CITY OF TAMPA

CONTRACT ADMINISTRATION DEPARTMENT

ADDENDUM NO. 1

Contract 14-C-00056; Harbour Island Roadway Surface Replacement

**DEMOLITION
 PARTIAL PLANS
 SECTIONS C & D**

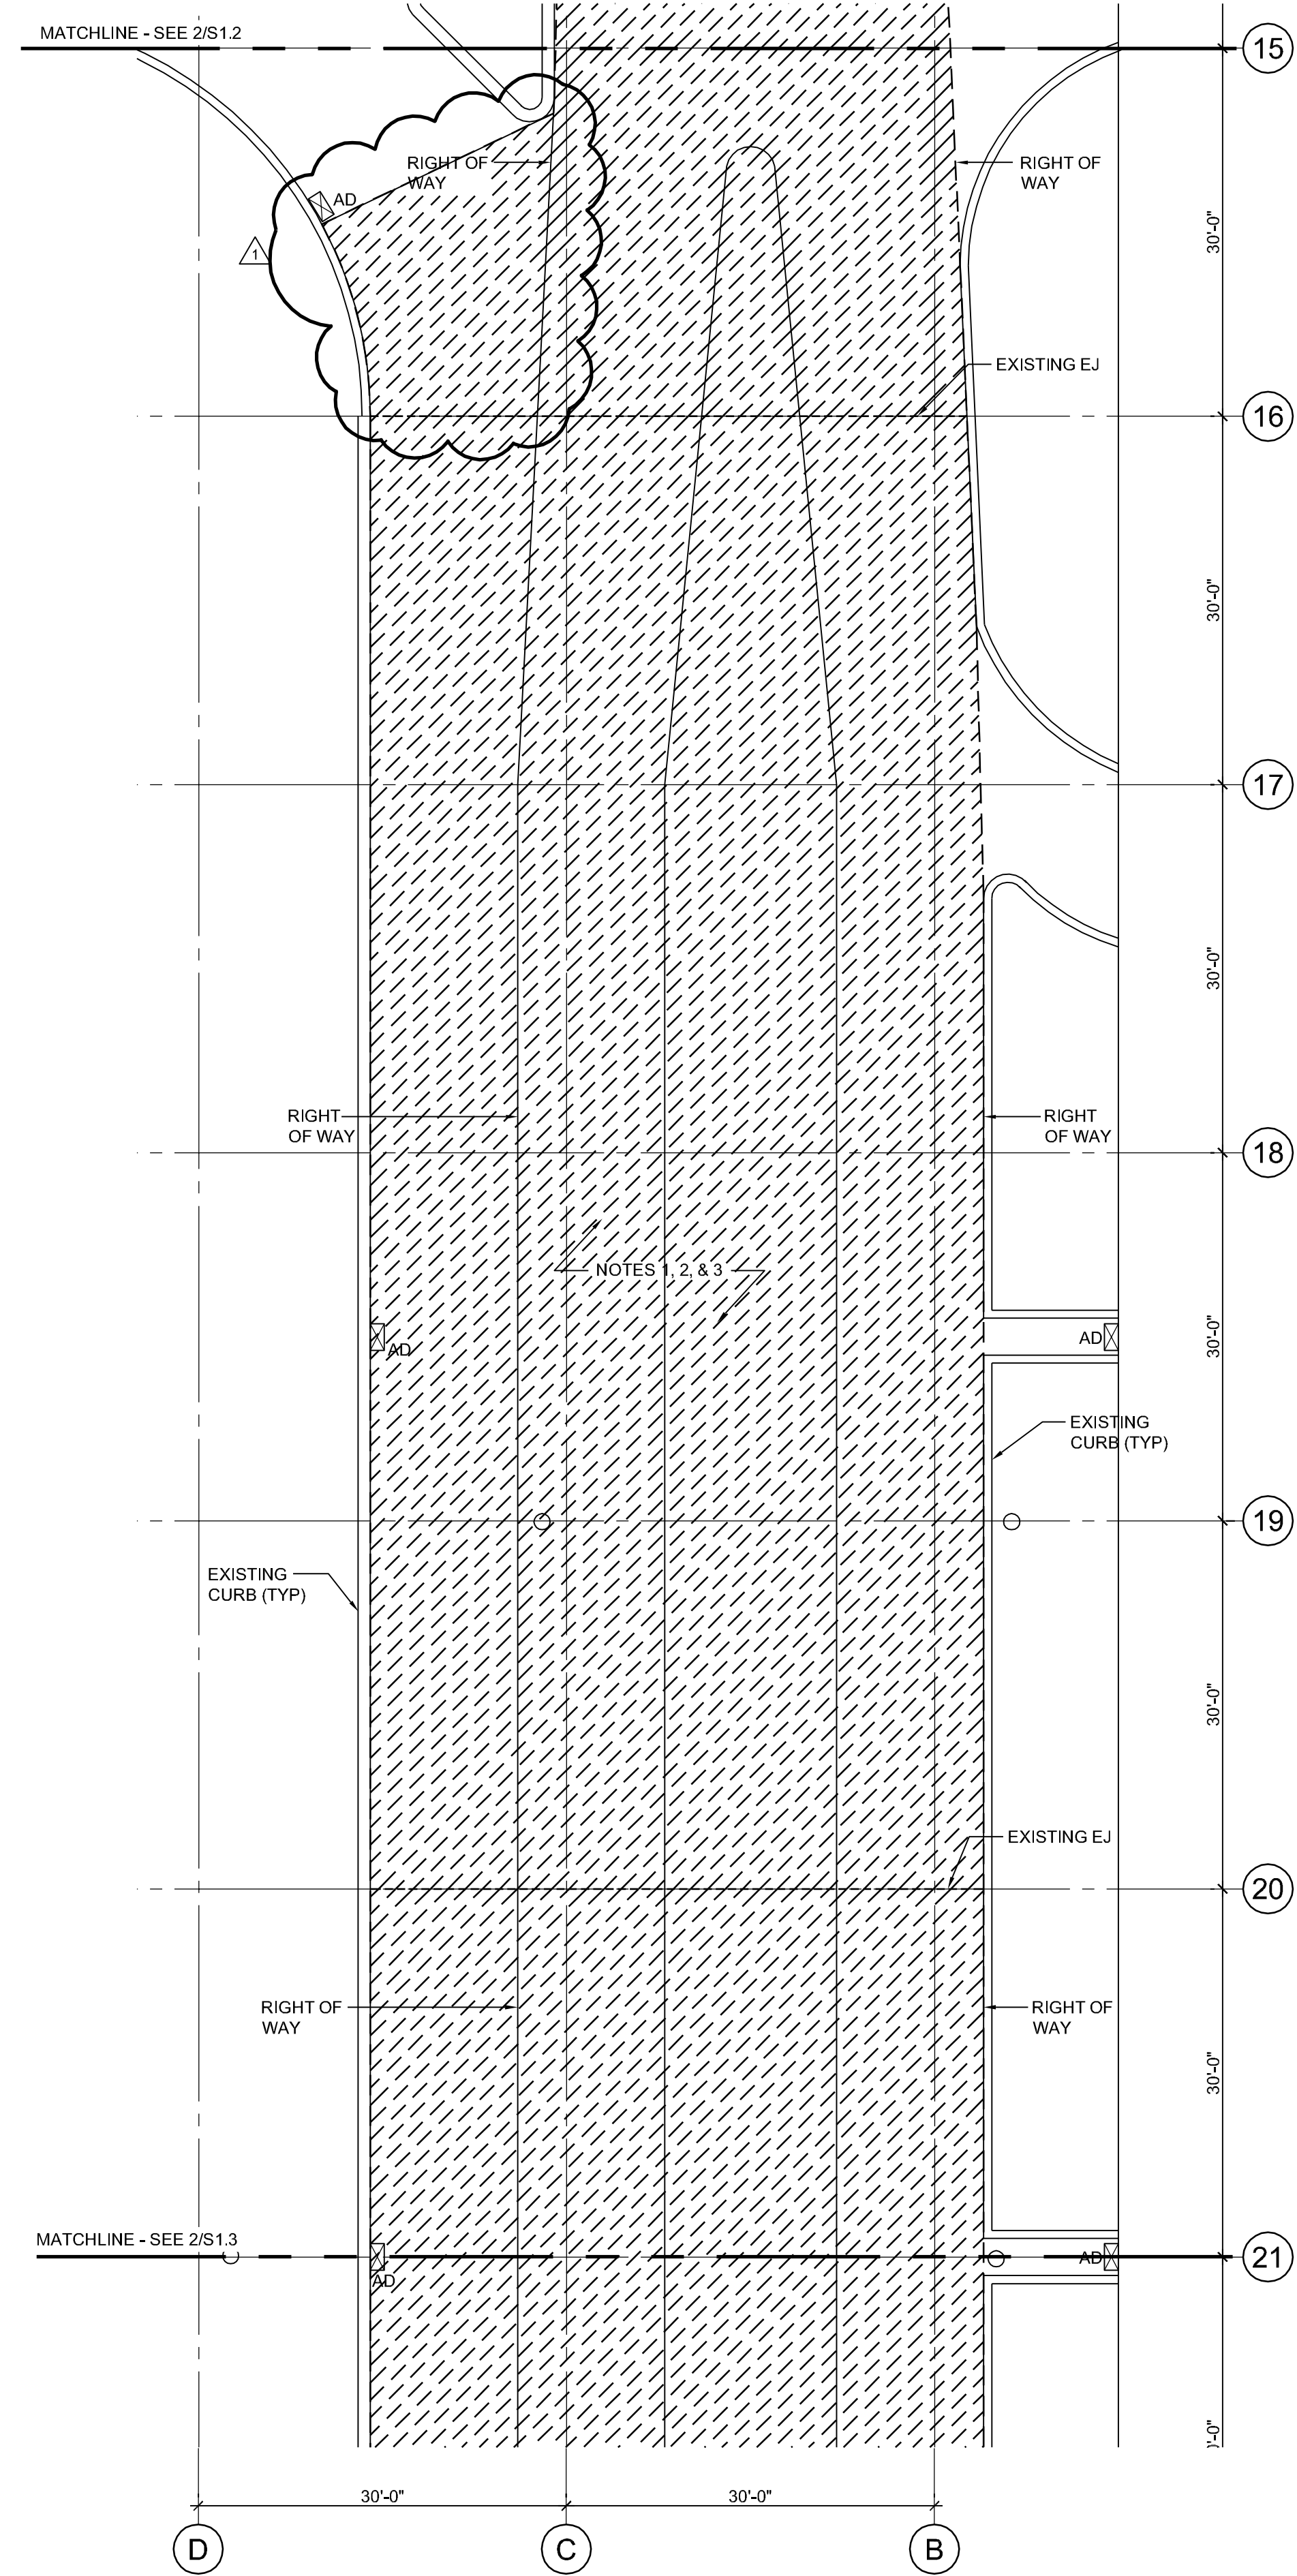
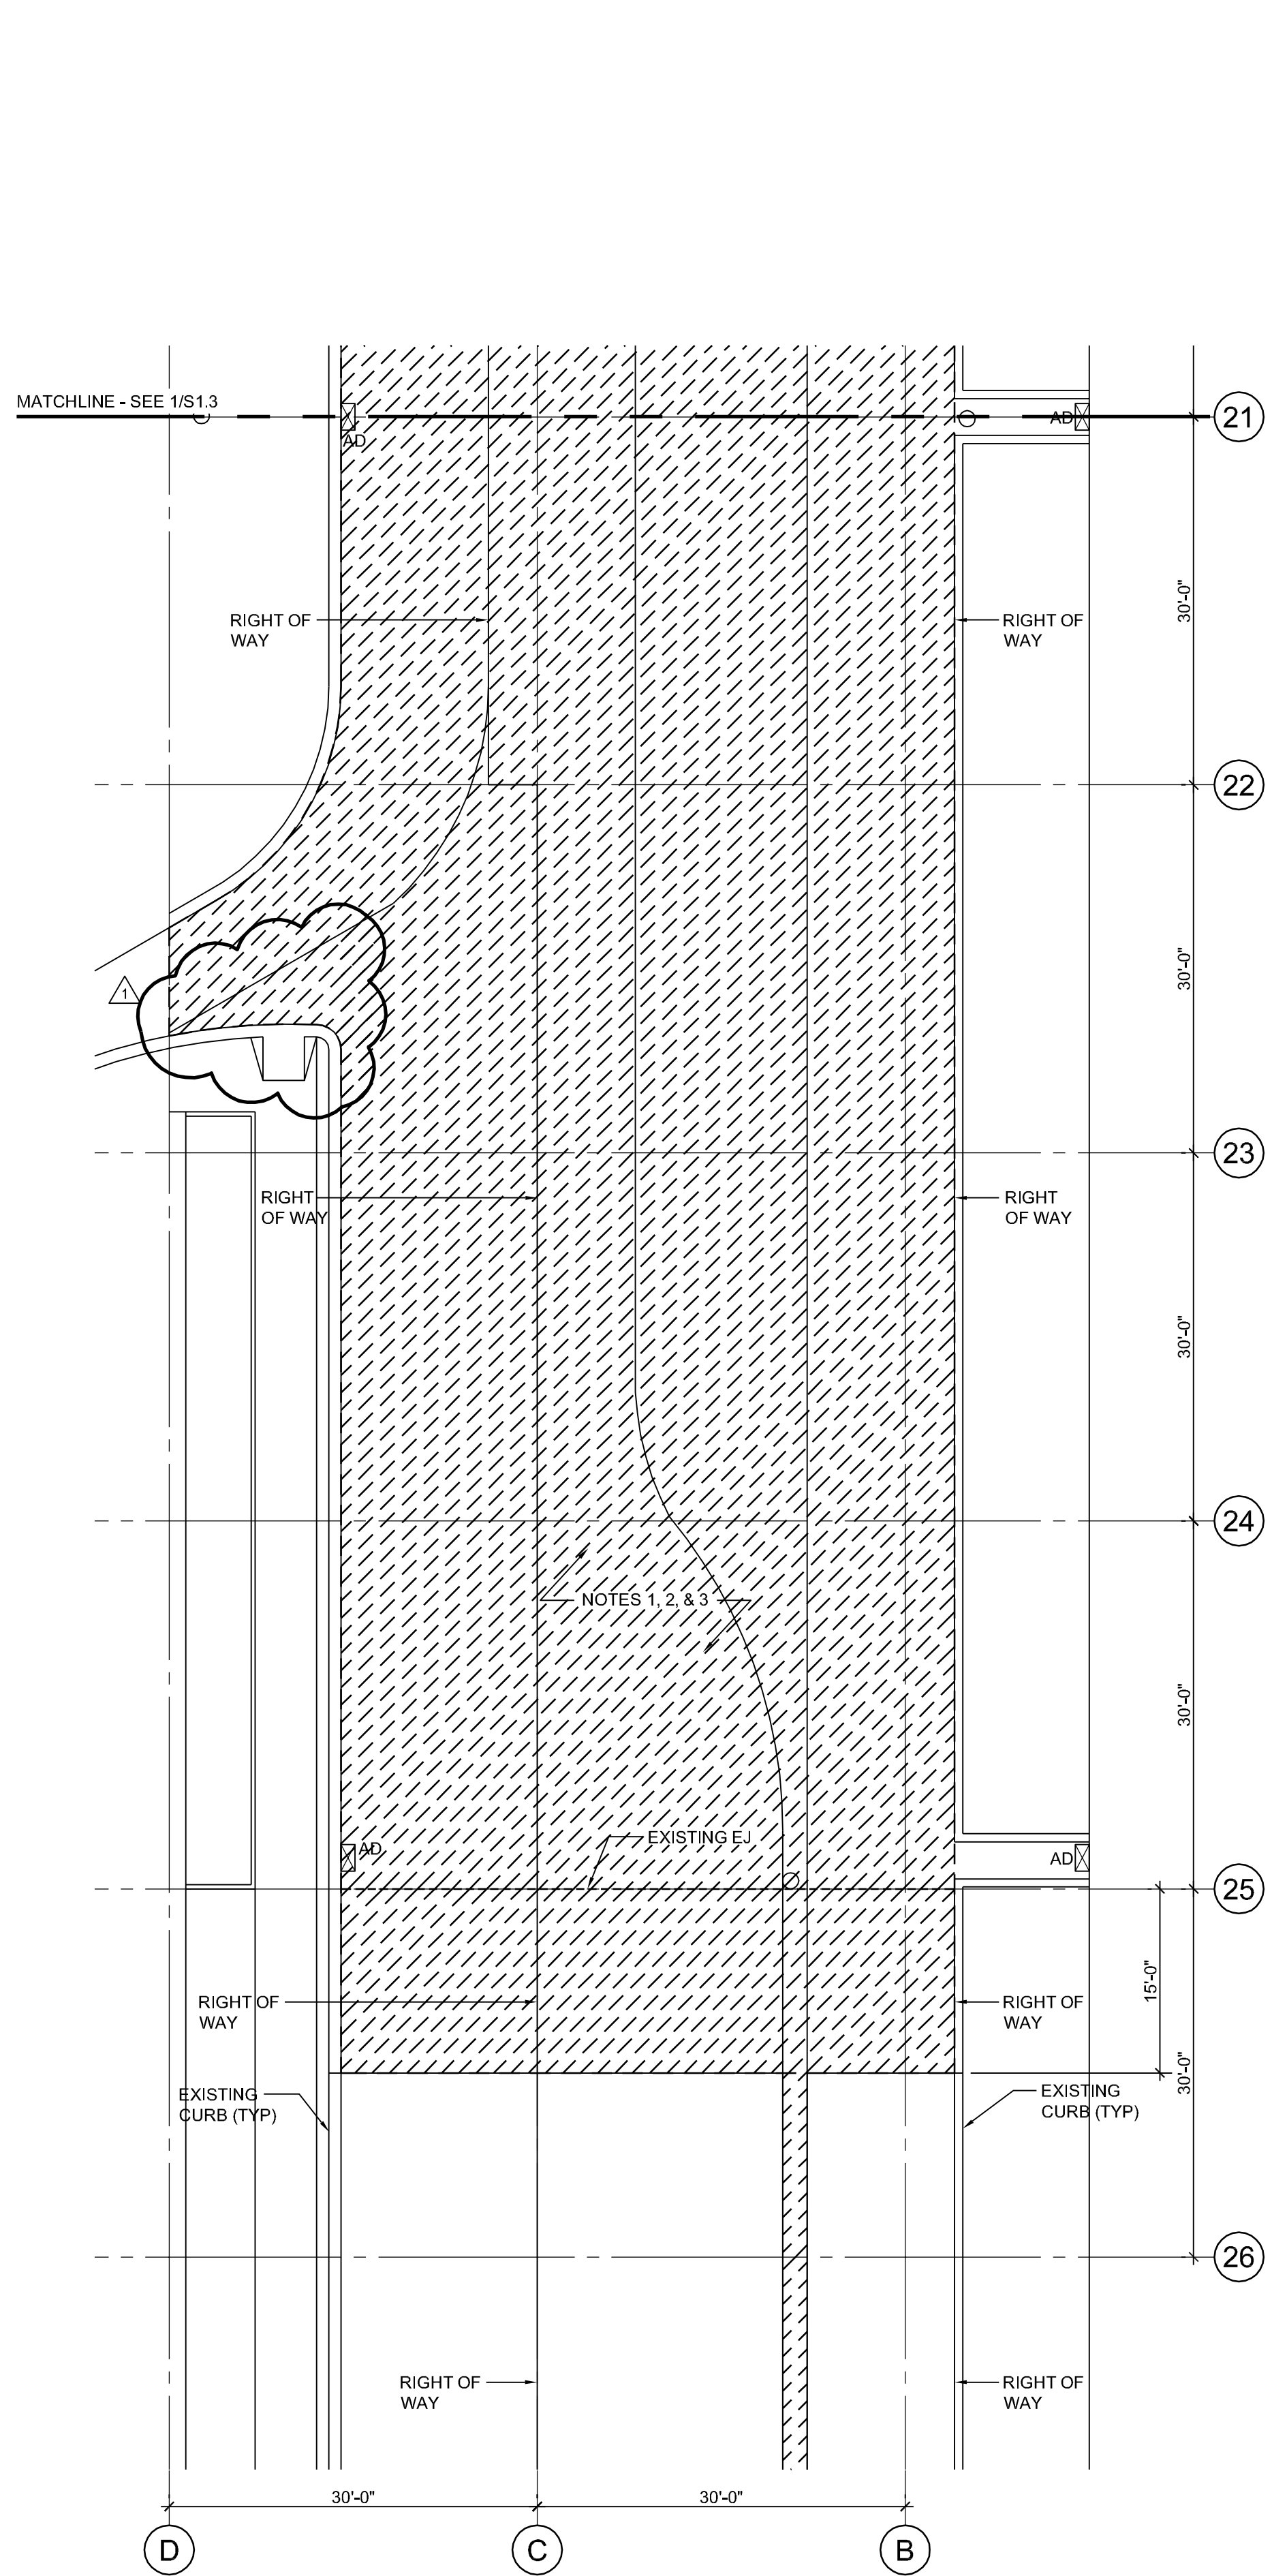
- Item 1: Replace Proposal page P-3 with the attached Proposal page P-3R
- Item 2: Section 01 10 00 Task Items, page 01 10 00 -7, T.I. 5.1 C. Execution: Delete paragraph 1.
- Item 3: Section 01 45 29 Structural Testing and Inspections, page 01 45 29 – 2, 1.5 Contractor Responsibilities: Delete paragraph A.
- Item 4: Replace Plan Sheets S1.3, S1.4, S1.5, and S2.0 with the attached, revised Plan Sheets S1.3, S1.4, S1.5, and S2.0.
- Item 5: Attached for reference is the pre-bid meeting sign-in sheet.

No.	Date	Description
△	08.DEC.14	ADDENDUM 1
